CITY OF ALBUQUERQUE

June 3, 2015

**Re: 17 Unit Townhouse Development
1120 Griegos Rd NW
Grading & Drainage Plan (F14D058)**

4 UNIT TOWNHOUSE DEVELOPMENT GRADING AND DRAINAGE PLAN			
DRAWING:	DRAWN BY:	DATE:	SHEET #
201418-GR.DWG	SH-B	12-22-2014

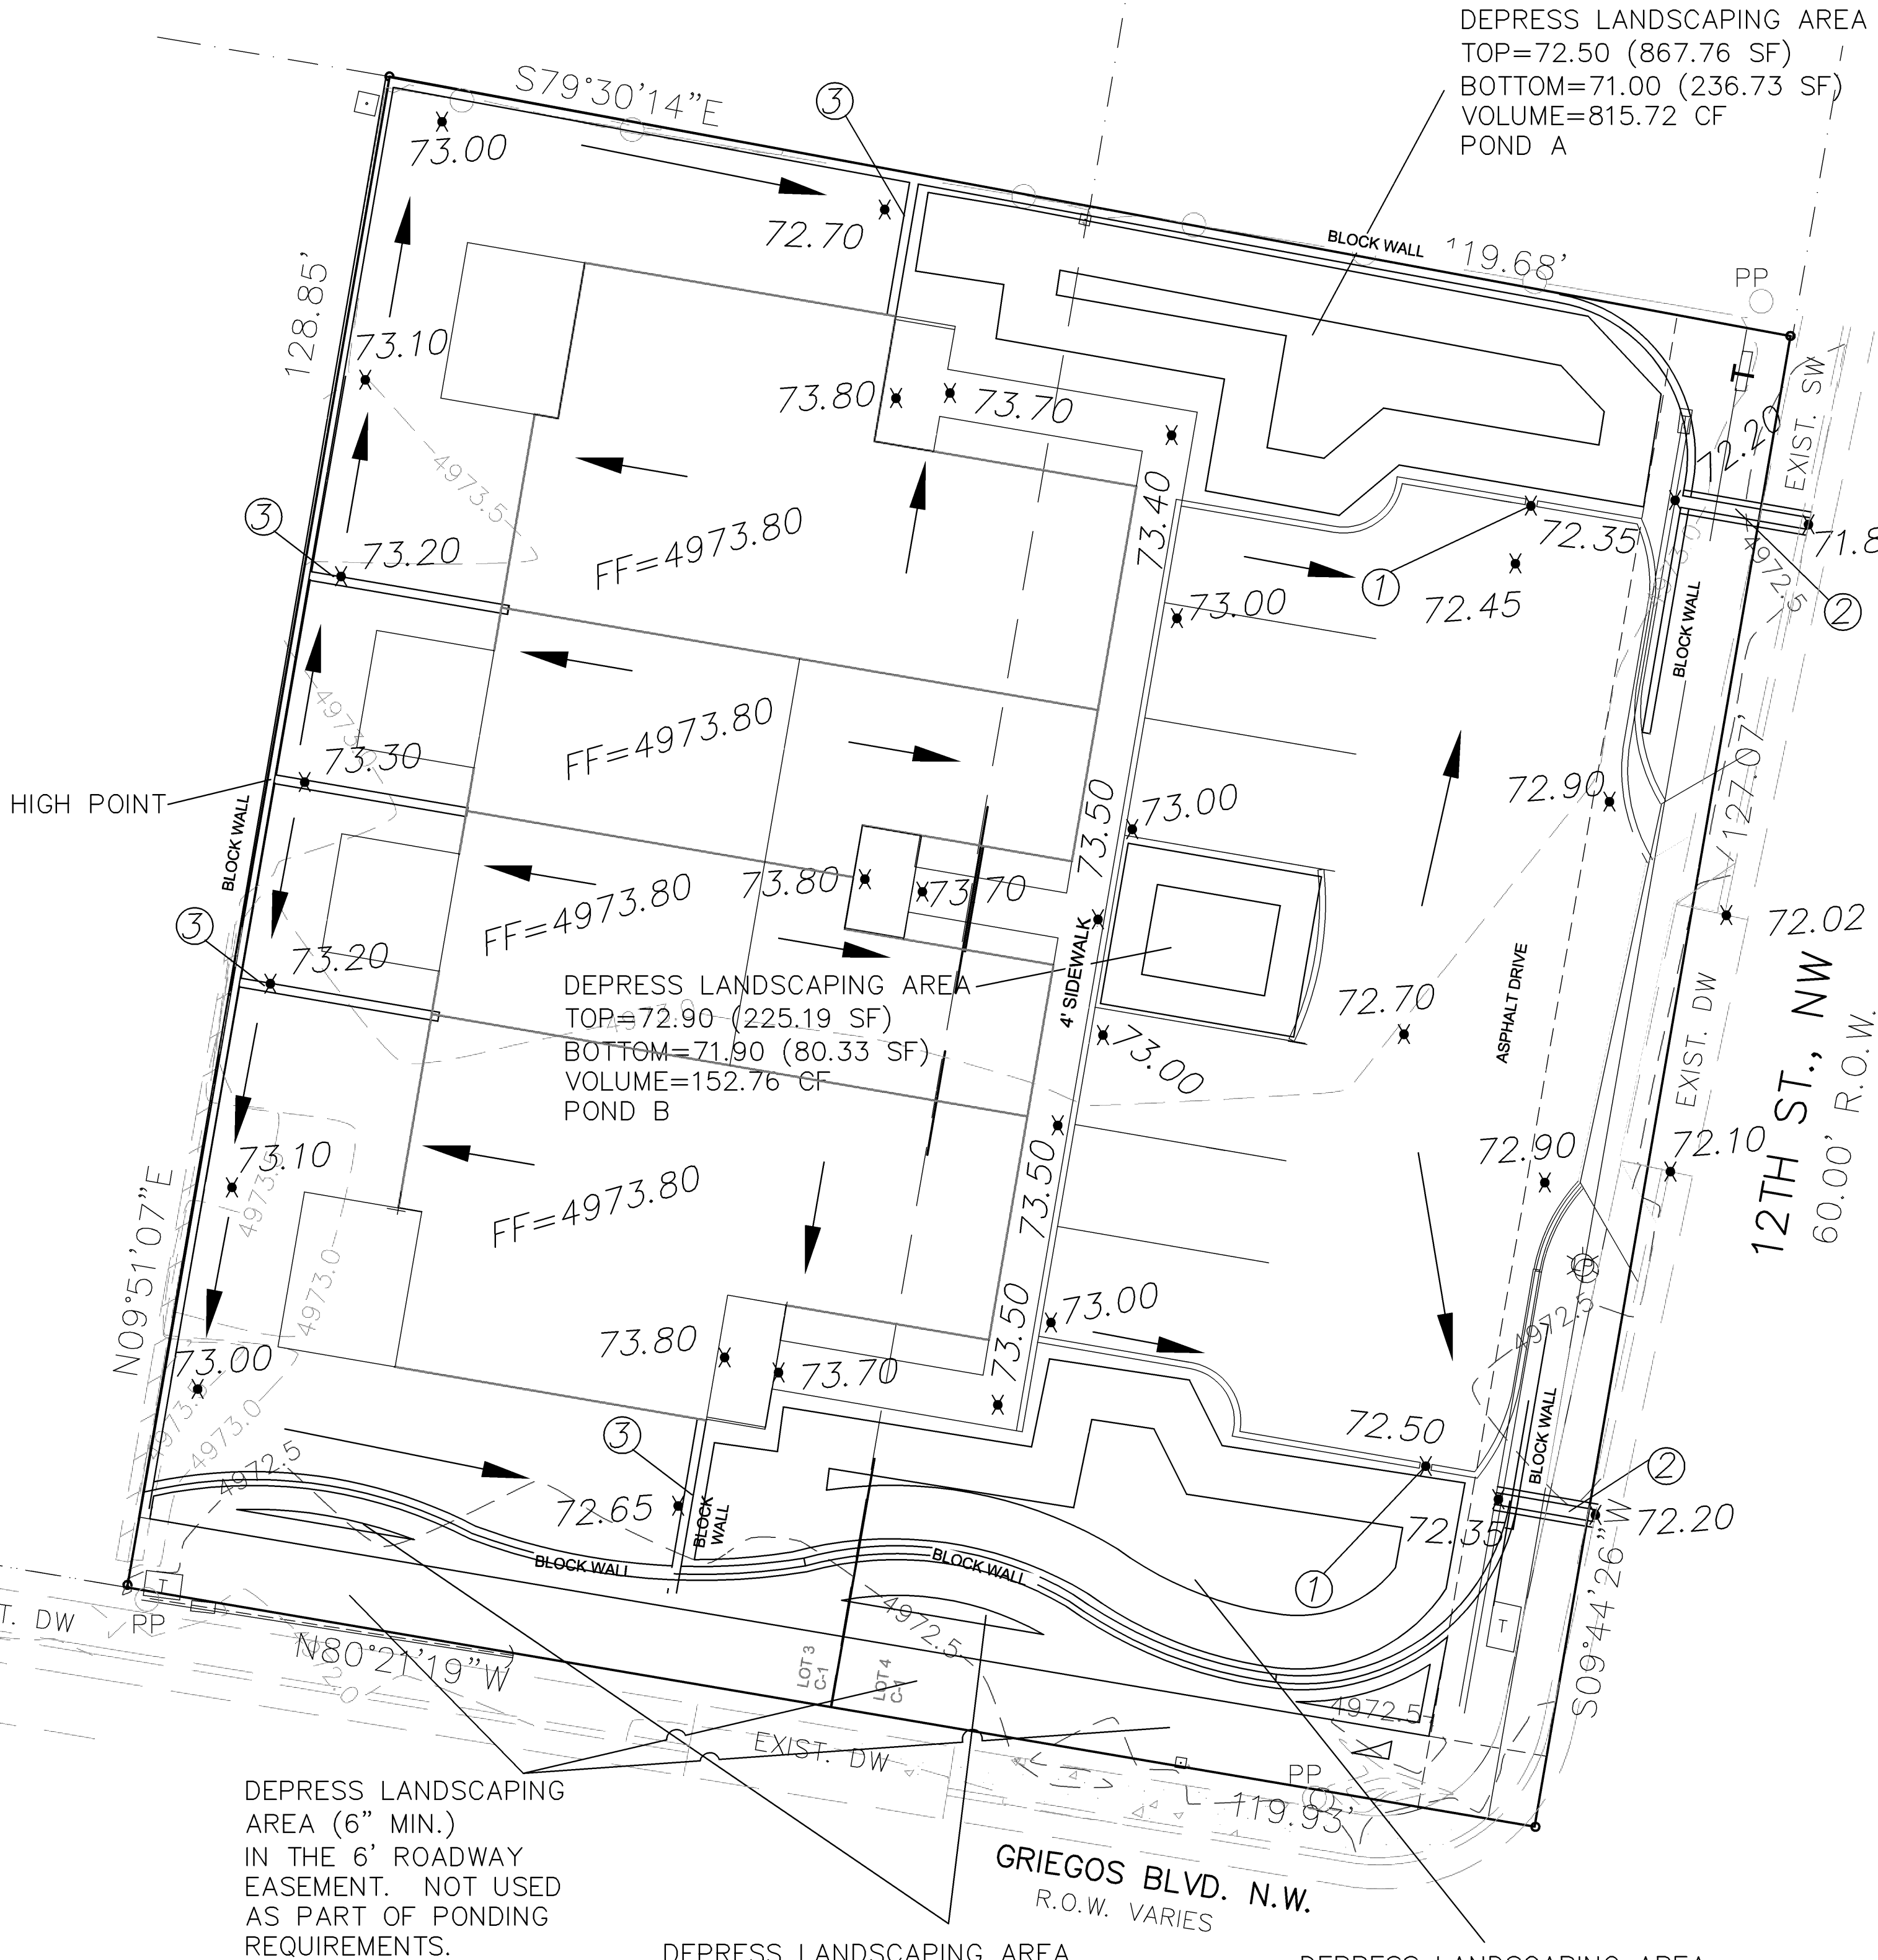
- Provide the roof flows.
- Label turn blocks at each wall or state typical opening for drainage.
- How are the flows handled to the east of this site?
- Extend the sidewalk culvert 1 foot passed the property line.
- An ESC plan is required and accepted by Curtis Cherne before BP approval.
